Work Order ID 92453

Item Name: Crosstube Fwd

DRAWING NO. D407-667-145	TITLE CROSSTUBE ASS'Y (407 HIGH FWD)	REV. C	DART AEROSPACE LTD ENGINEERING ORDER		D.E.O. NO. D407-667-145-C-1	SHEET NO. SHEET 1 OF 1	SCALE NTS
DRAWN <i>q</i>	CHECKED <i>ASS</i>	MFG. APPR. <i>18</i>	APPROVED <i>WD</i>		DE APPR. <i>11</i>		
DATE 11.07.15	DATE 11.07.22	DATE 11.07.22	DATE 11/07/22		DATE 11.07.21

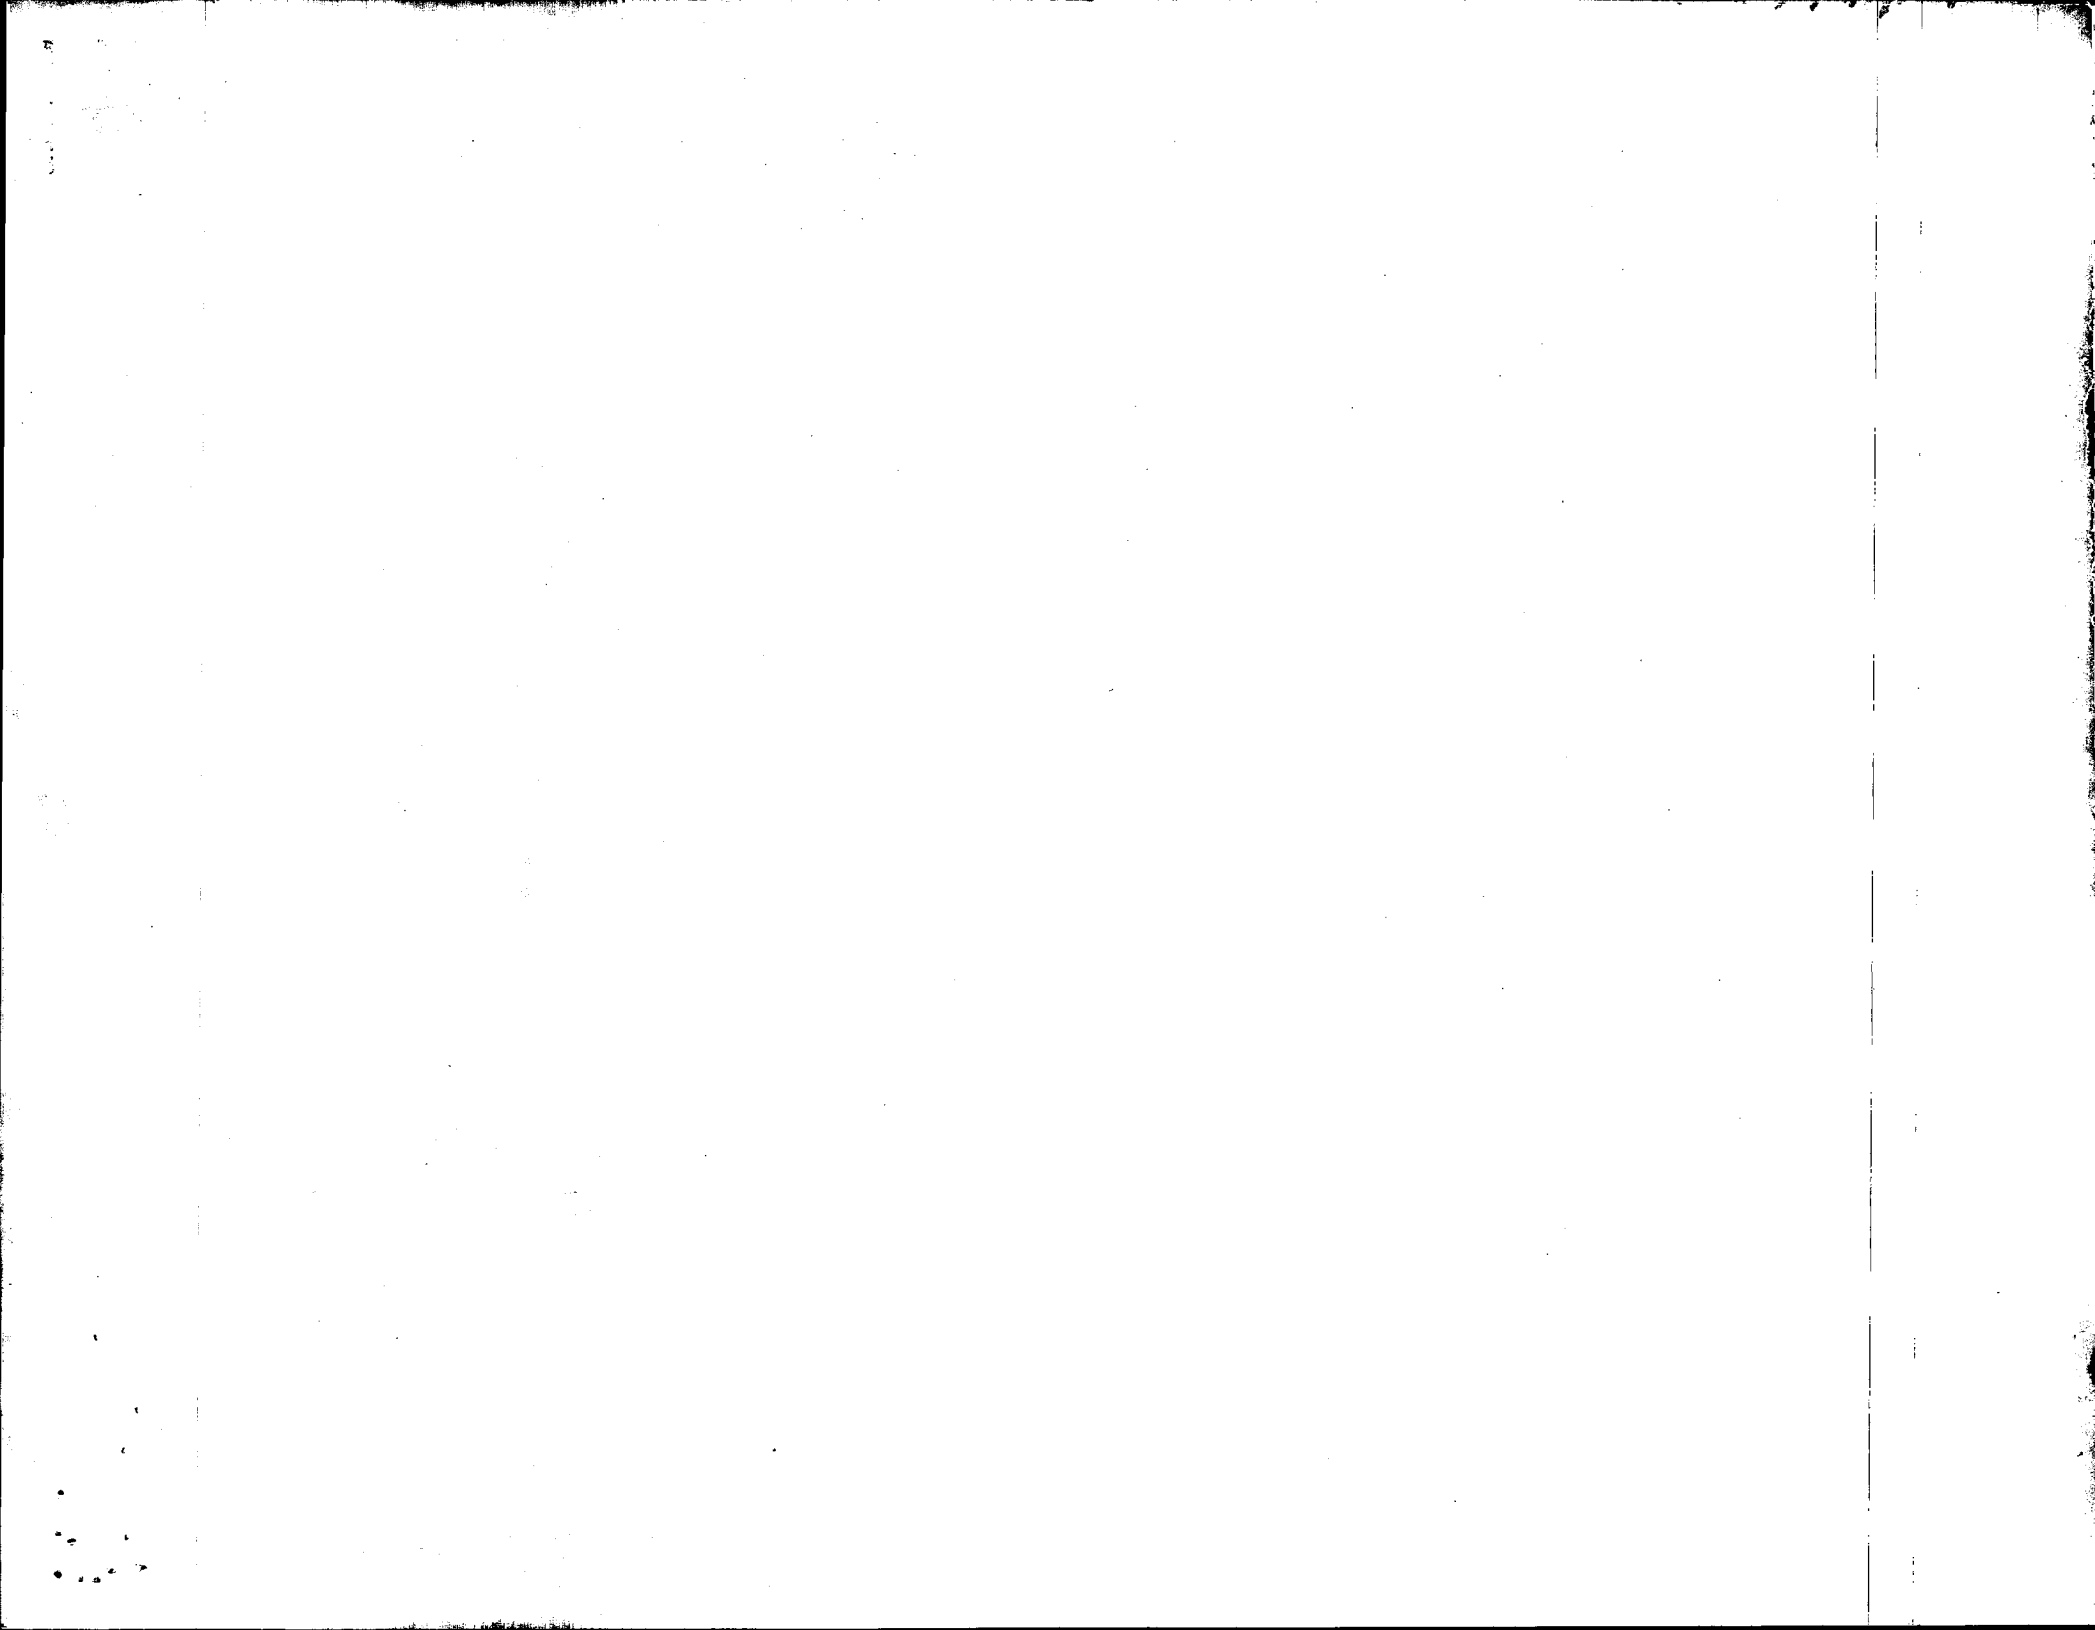
REPLACE MAGNOBOND WITH PROSEAL.

NOTE 12 & 15, SHEET 1 IS AMENDED AS FOLLOWS:

- 12) TO INSTALL D2891-1 SUPPORT: ABRASE MATING SURFACE OF SUPPORT AND CROSSTUBE WITH 180-GRIT SANDPAPER AND REMOVE RESIDUE WITH MEK (OR EQUIVALENT). APPLY A 0.04" TO 0.07" THICK LAYER OF PROSEAL 890 CLASS B-2 (OR AMS-S-8802 CLASS B-2) SEALANT TO MATING SURFACE OF SUPPORT.
- 15) TORQUE CLAMPS 80 TO 100 IN-LB. ENSURE AT LEAST 1.5 THREADS SHOWING IN SAFETY AND THAT NUT HAS NOT BOTTOMED-OUT AFTER TORQUING. **PRIOR TO PACKAGING, RE-CHECK TORQUE ON CLAMPS AFTER PROSEAL 890 SEALANT HAS CURED FOR 72 HOURS.**

DRAWING NO. D407-667-145	TITLE CROSSTUBE ASS'Y (407 HIGH FWD)	REV. C	DART AEROSPACE LTD ENGINEERING ORDER		D.E.O. NO. D407-667-145-C-2	SHEET NO. SHEET 1 OF 1	SCALE NTS
DRAWN AJS	CHECKED	MFG. APPR.	APPROVED	DE APPR.	DATE 12.08.02	DATE 12.08.02	DATE 12.08.02

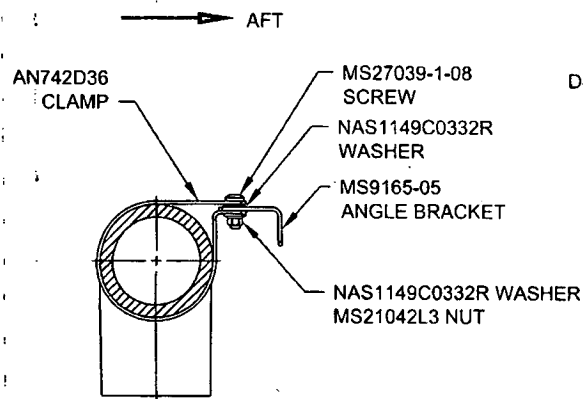
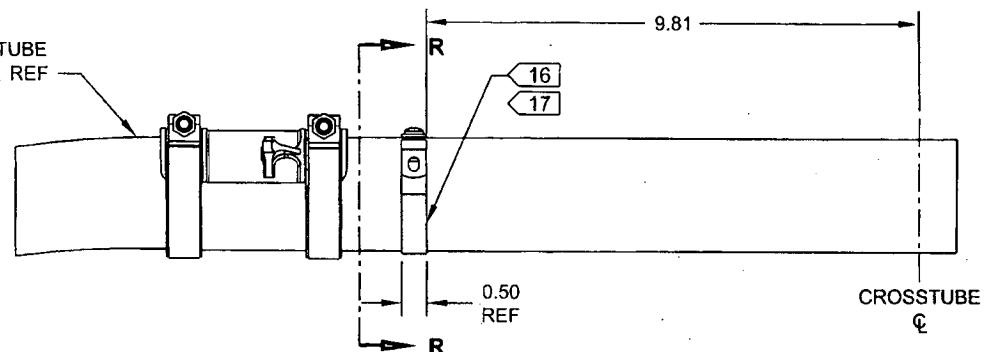
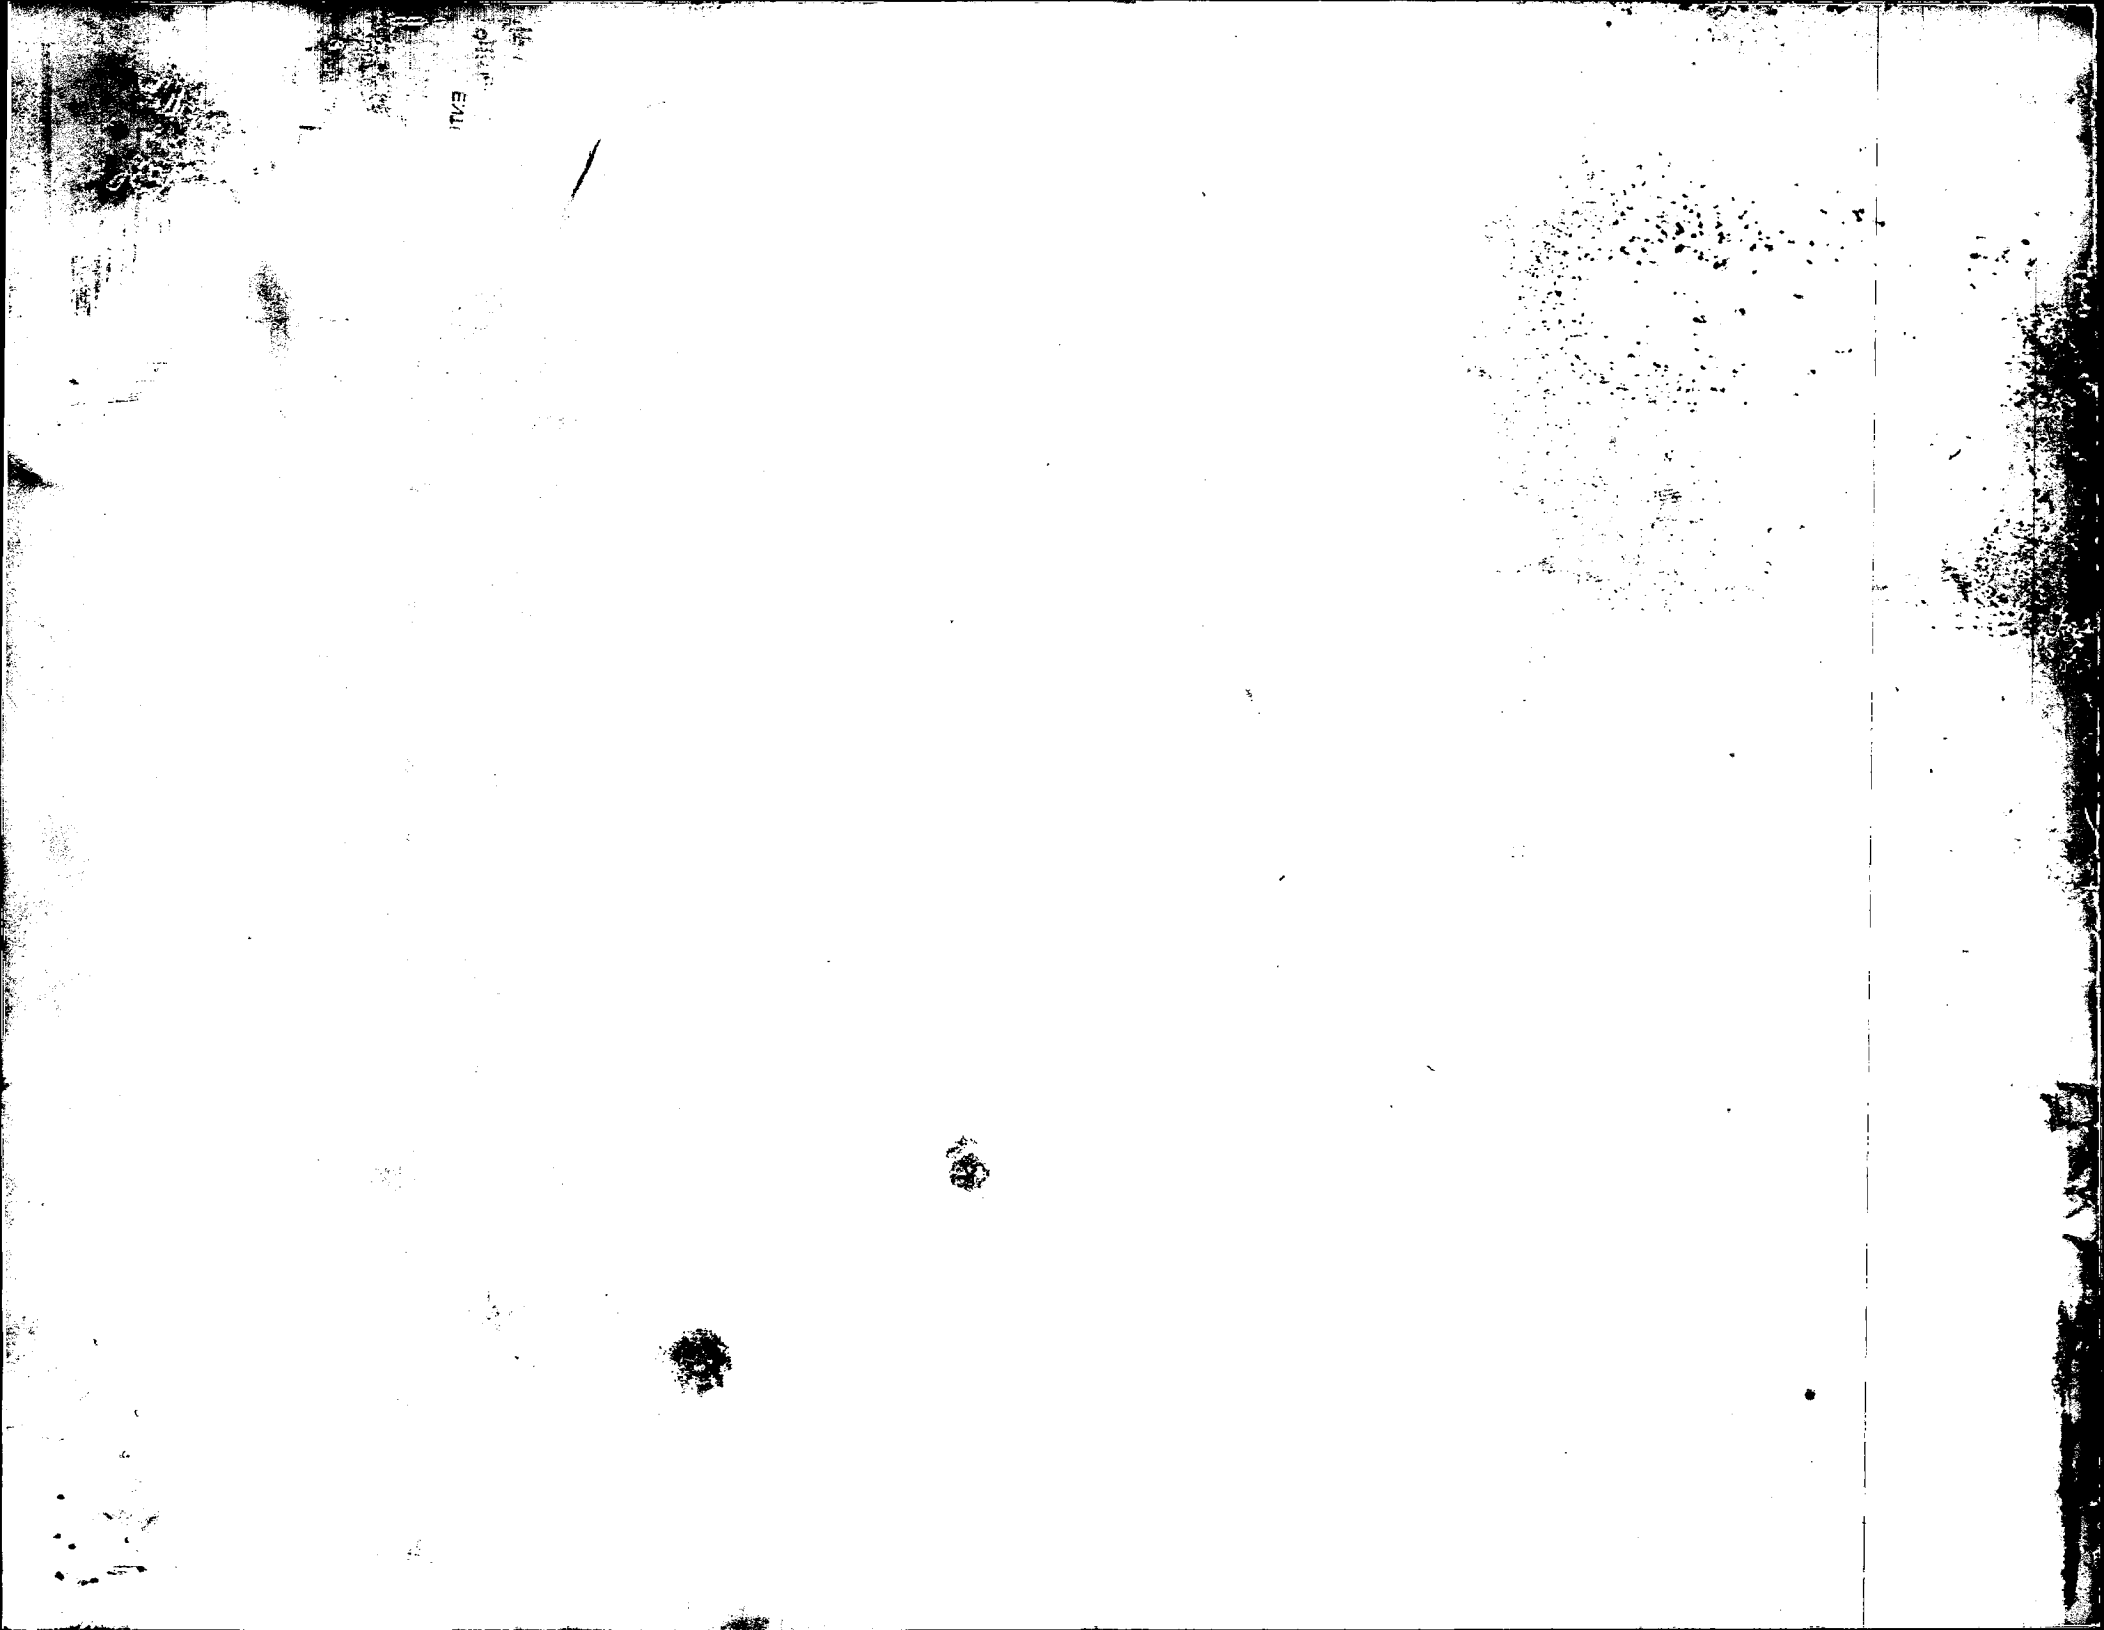
ADD ELECTRICAL GROUNDING STRAP

ITEM	QTY	PART NUMBER	DESCRIPTION
1	X	D407-667-145	CROSSTUBE ASSEMBLY (407 HIGH FWD)
10	2	AN742D36	CLAMP
11	2	MS9165-05	ANGLE BRACKET
12	2	MS21042L3	NUT (OR MS21042-3)
13	2	MS27039-1-08	SCREW
14	4	NAS1149C0332R	WASHER (OR AN960C10L)

DETAIL P
BONDING STRAP INSTALLATION 2 PL
